We first like to thank the reviewer for the comprehensive, fair and constructive comments. Please find our answers to the comments below. We marked the [reviewers comments blue](#) and our answers black.

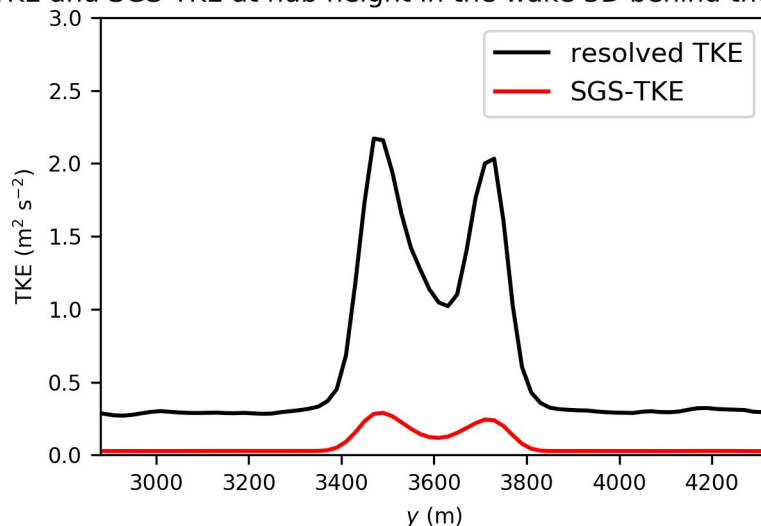
In Figs 5 and 6, scale is inverse with respect to the other (red to green and green to red), please maintain consistency to denote low to large values in scaling. Furthermore, it is rather common to see blue to red to depict small to large values (e.g. subfigure (f) in figures 4, 6 and 7), so to use blue in the middle can be somewhat disconcerting. Is this perhaps a choice to highlight the wakes behind the clusters?

This choice is intentional. Blue and especially red should indicate the wake, which is smaller wind speed but higher TI. We put blue in the middle to avoid a green-red color transition which might be difficult to see for red-green colorblind people.

TKE and SGS-TKE at hub height in the wake 3D behind the turbine

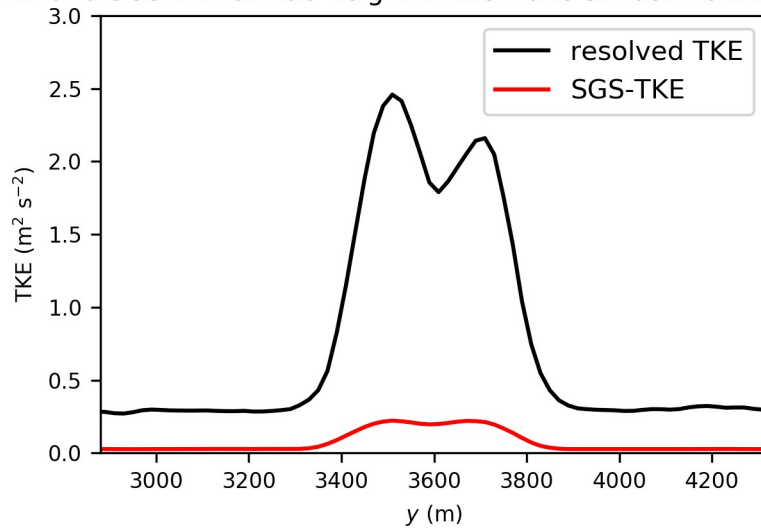
L386, the TKE does consider the subgrid scales. Since the resolution is relatively coarse to resolve the flow around the rotors, a sizable part of the TKE is potentially found within the subgrid scales. Please provide an argument regarding why only resolved scales should be considered in this analysis.

Resolved and SGS-TKE is displayed in the following figures and justifies that the SGS-TKE has no significant contribution here.

In line 387 (equation for TI and TKE) we added:

“The SGS-TKE is neglected, because it is smaller than 10 % of the resolved TKE, inside the wind turbine wakes at a distance of 3D or more.”
